VILLAGE OF WEST LAFAYETTE
COSHOCTON COUNTY, OHIO

WWTP OUTFALL & STORM SEWER OUTFALL IMPROVEMENTS

ADDENDUM #1

AUGUST 22, 2023

PHASE No.	WEST LAFAYETTE WWTP OUTFALL AND STORM SEWER OUTFALL IMPROVEMENTS	SHEET No.	6
CONTRACT No.			
PROJECT No.	020-10127

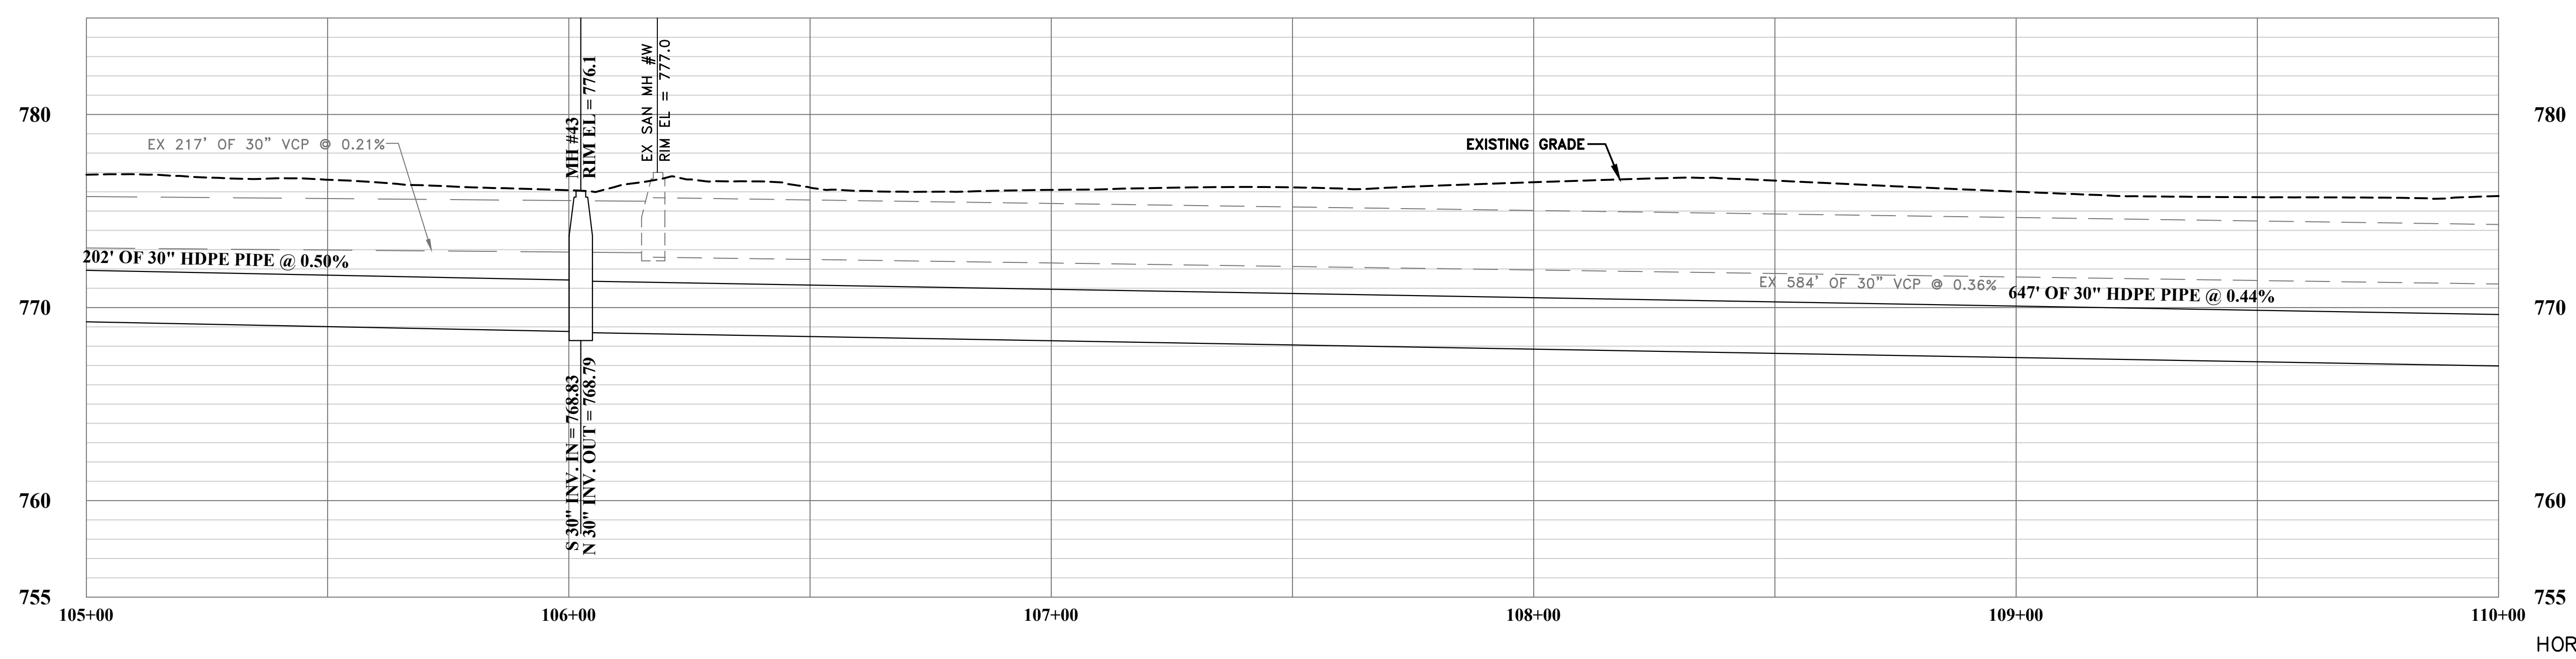
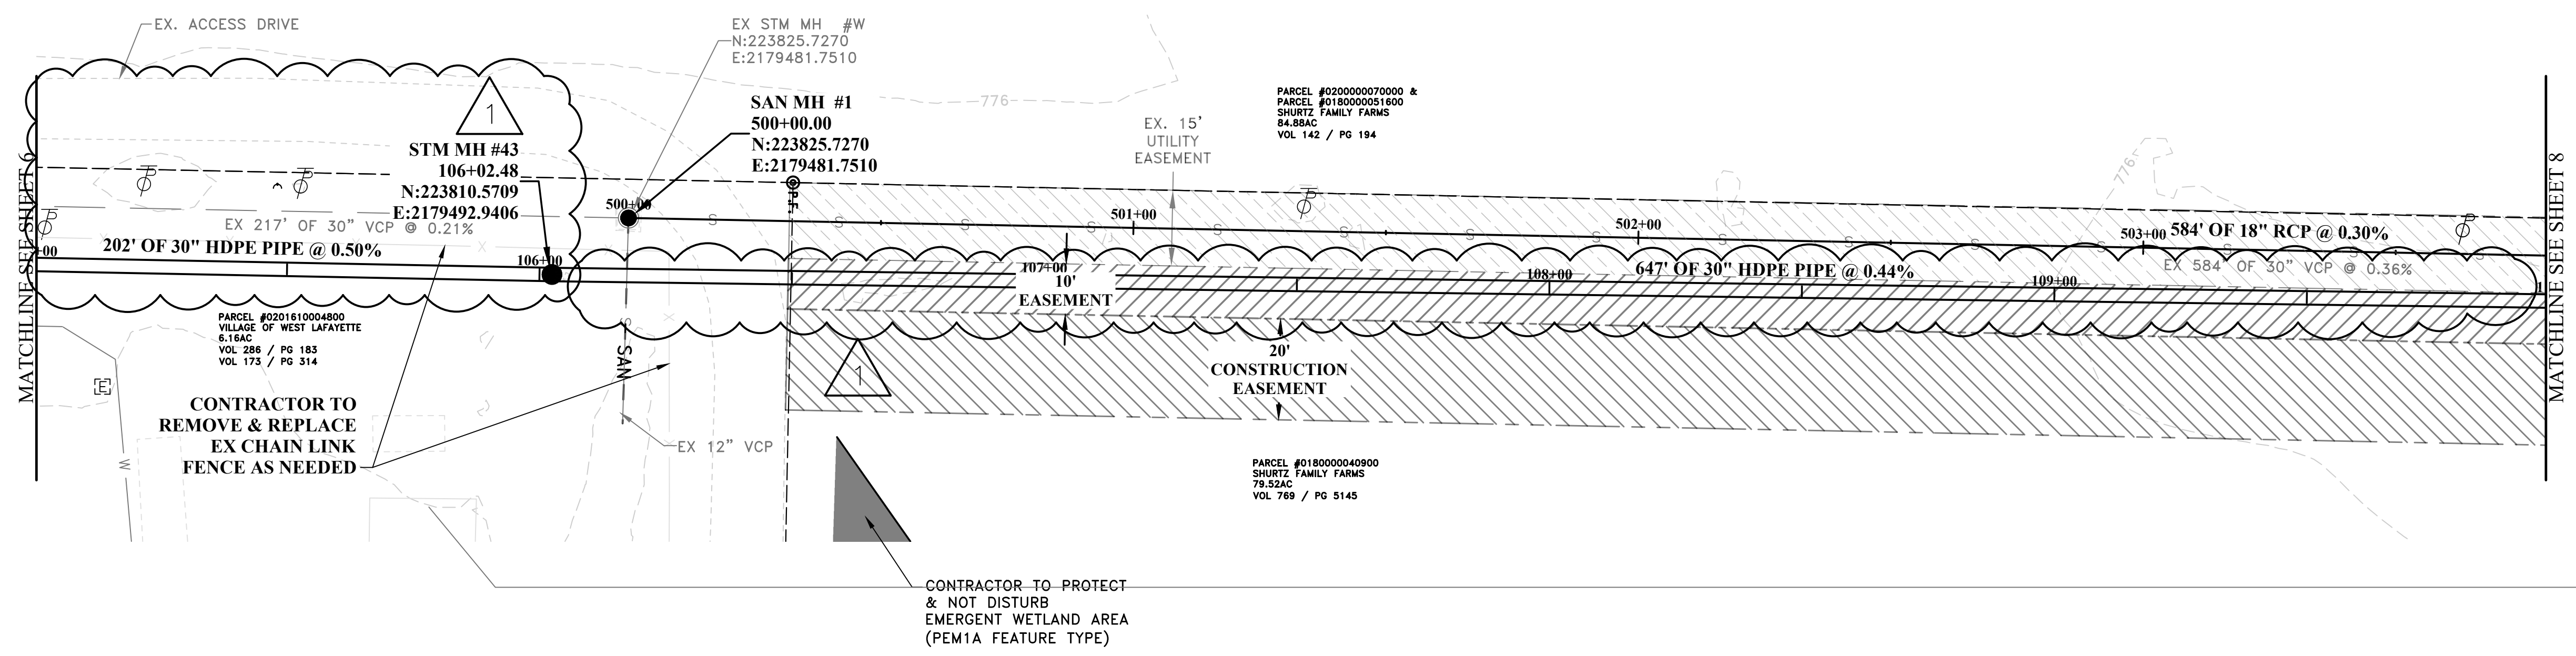
NO.	BY	DATE	DESCRIPTION
1	AMF	21AUG2023	MOVED THE MANHOLE TO AVOID WATER CROSSING AND MANHOLE ADJUST

SHEET No.
7

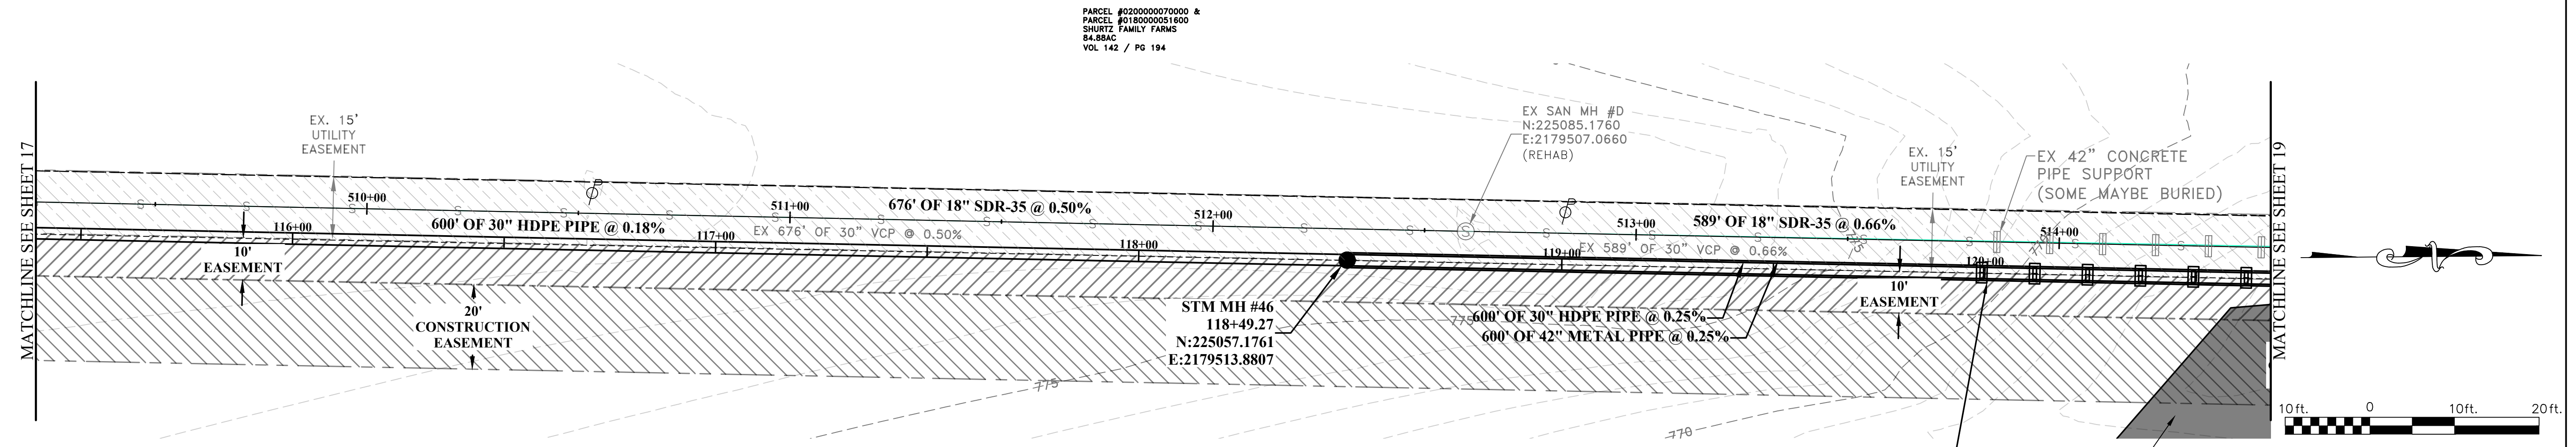
NO.	BY	DATE	DESCRIPTION
1	AMF	21AUG2023	REALIGNED PIPE TO BE 5' FROM FENCE

PHASE No.	WEST LAFAYETTE WWTP OUTFALL AND STORM SEWER OUTFALL IMPROVEMENTS	SHEET No.	18
CONTRACT No.			
PROJECT No.	020-10127		
PLAN & PROFILE SAN 509+22-514+50

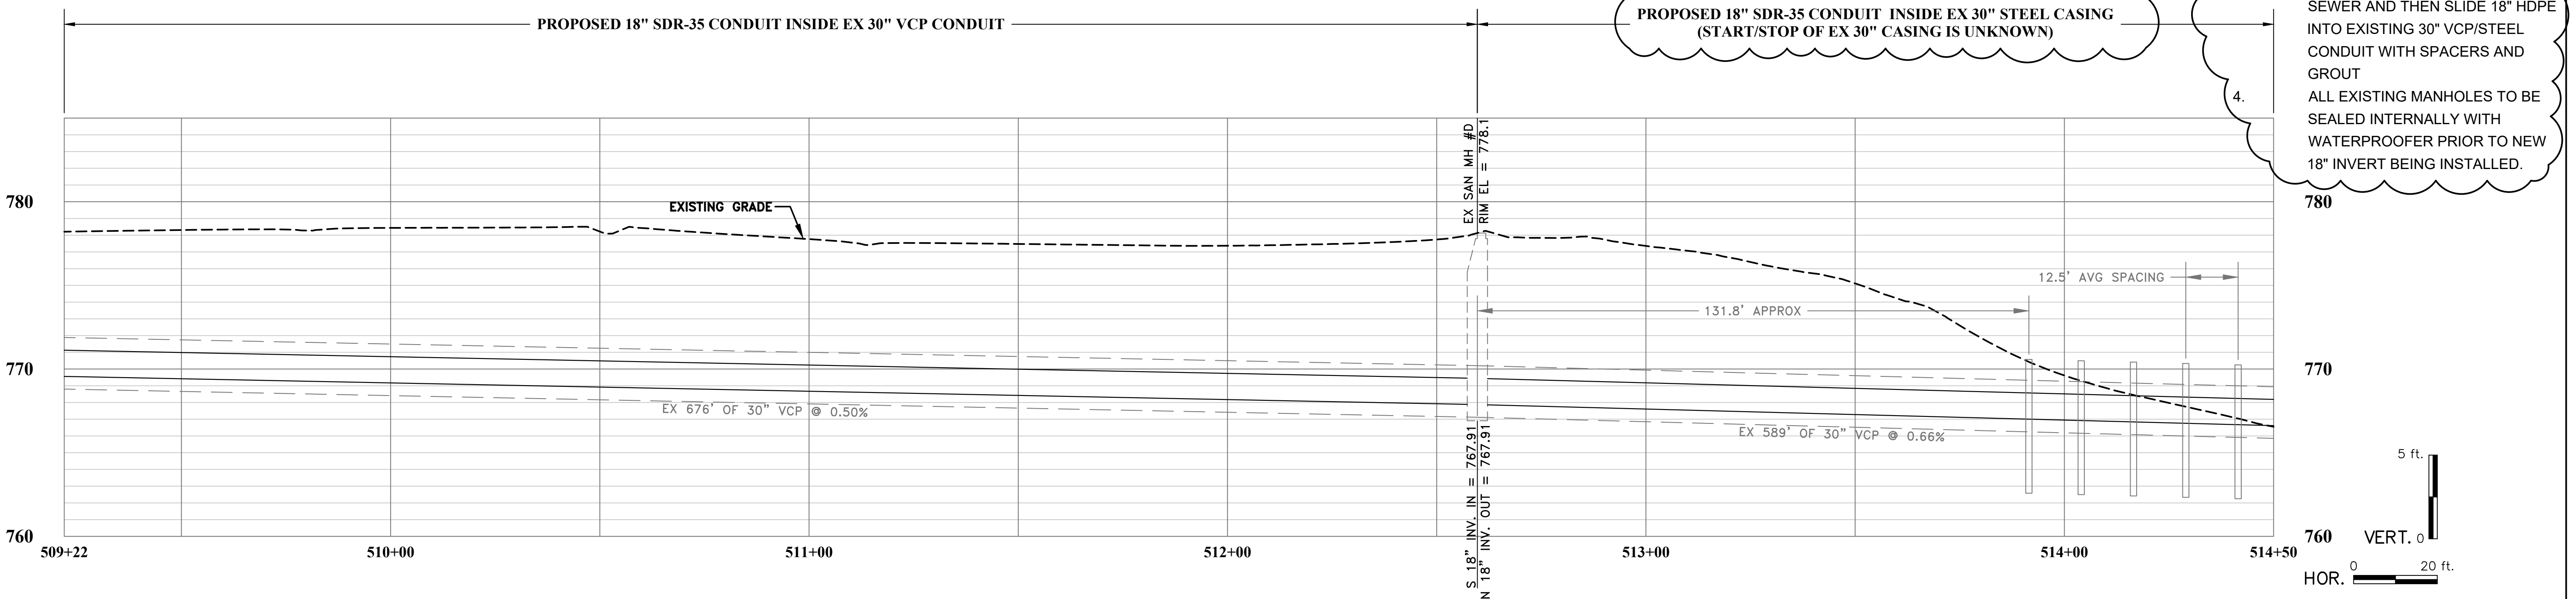
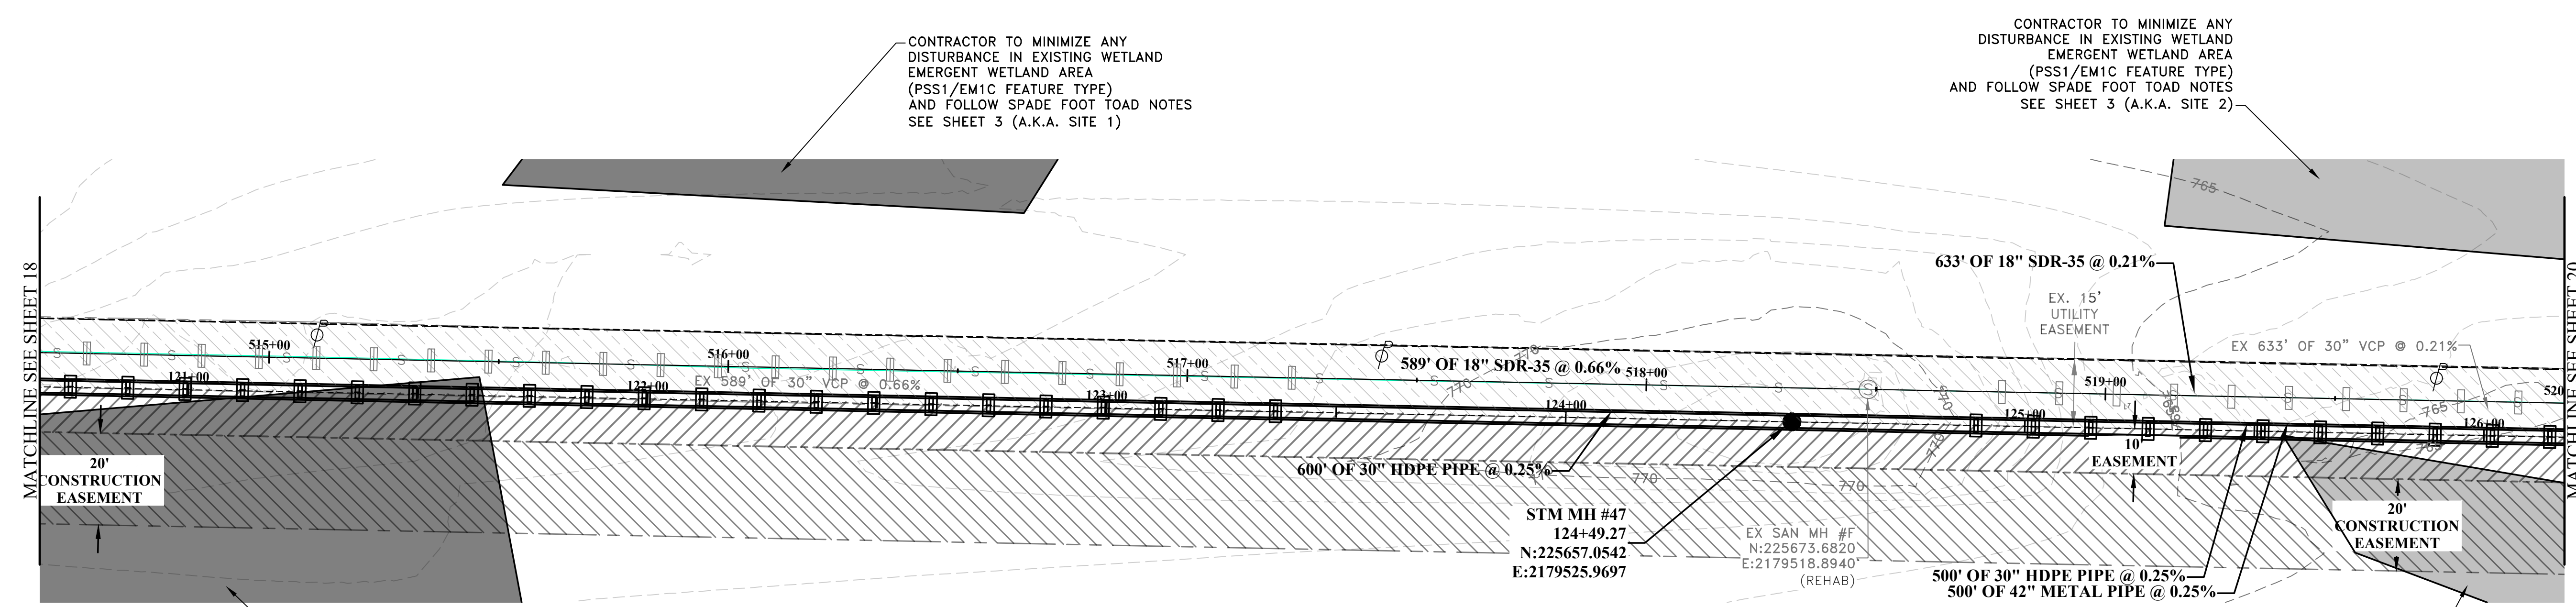
1. Is the detail on page 27 used only on the pile pointed to on sheet 18?

THE INFORMATION CONTAINED HEREIN IS THE SOLE PROPERTY OF THE THRASHER GROUP INC. REPRODUCTION OF THESE DOCUMENTS IN WHOLE OR IN PART, FOR ANY REASON WITHOUT PRIOR WRITTEN PERMISSION, IS STRICTLY PROHIBITED. COPYRIGHT © 2021 THE THRASHER GROUP INC.			
NO.	BY	DATE	DESCRIPTION
1	AMF	21AUG2023	CORRECTED STEEL PIPE SIZE

The detail on page 27 is used for all piles in the project. There are a total of 58 piers with 2 Helical piles per pier.

PHASE No.	WEST LAFAYETTE WWTP OUTFALL AND STORM SEWER OUTFALL IMPROVEMENTS	SHEET No.	19
CONTRACT No.			
PROJECT No.	020-10127		
PLAN & PROFILE SAN 514+50-520+00

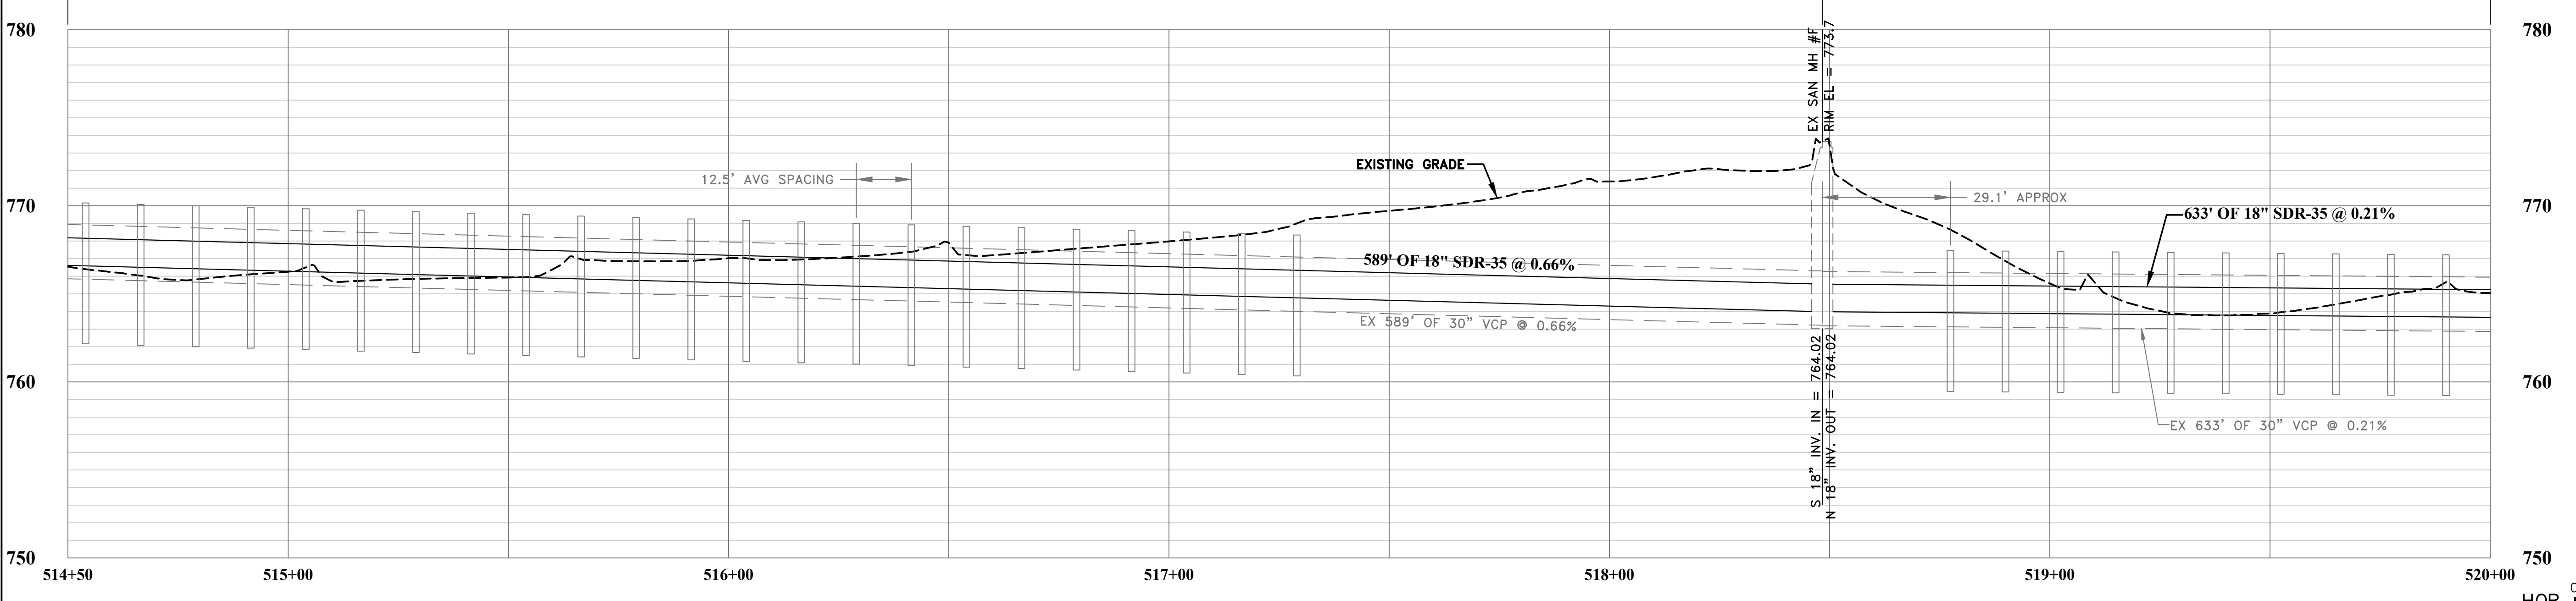
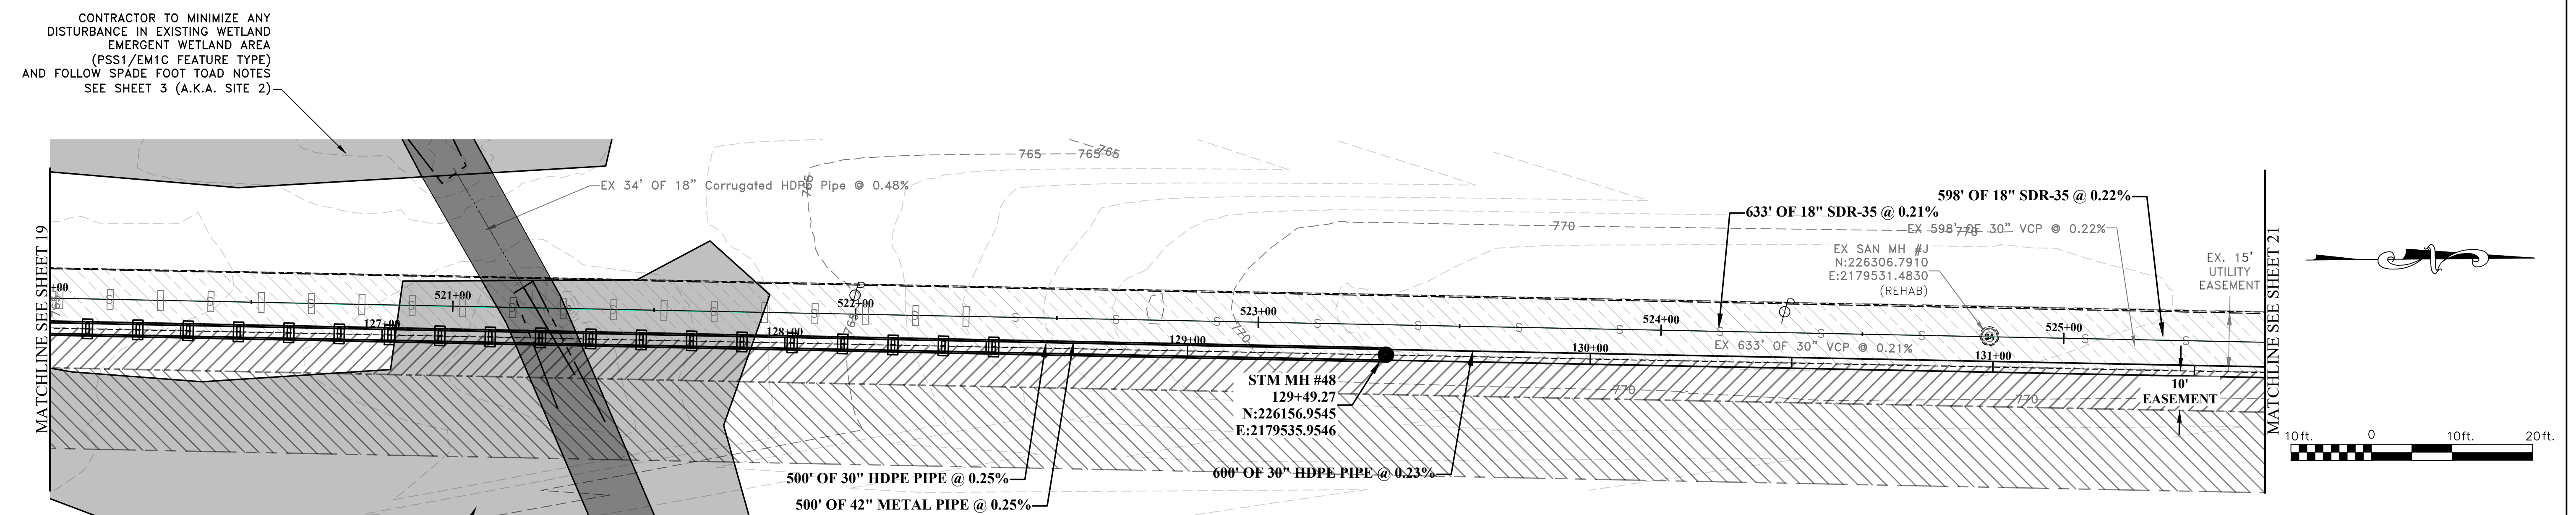
THE INFORMATION CONTAINED HEREIN IS THE SOLE PROPERTY OF THE THRASHER GROUP INC. REPRODUCTION OF THESE DOCUMENTS IN WHOLE OR IN PART, FOR ANY REASON WITHOUT PRIOR WRITTEN PERMISSION, IS STRICTLY PROHIBITED. COPYRIGHT © 2021 THE THRASHER GROUP INC.			
NO.	BY	DATE	DESCRIPTION
1	AMF	21AUG2023	CORRECTED STEEL PIPE SIZE
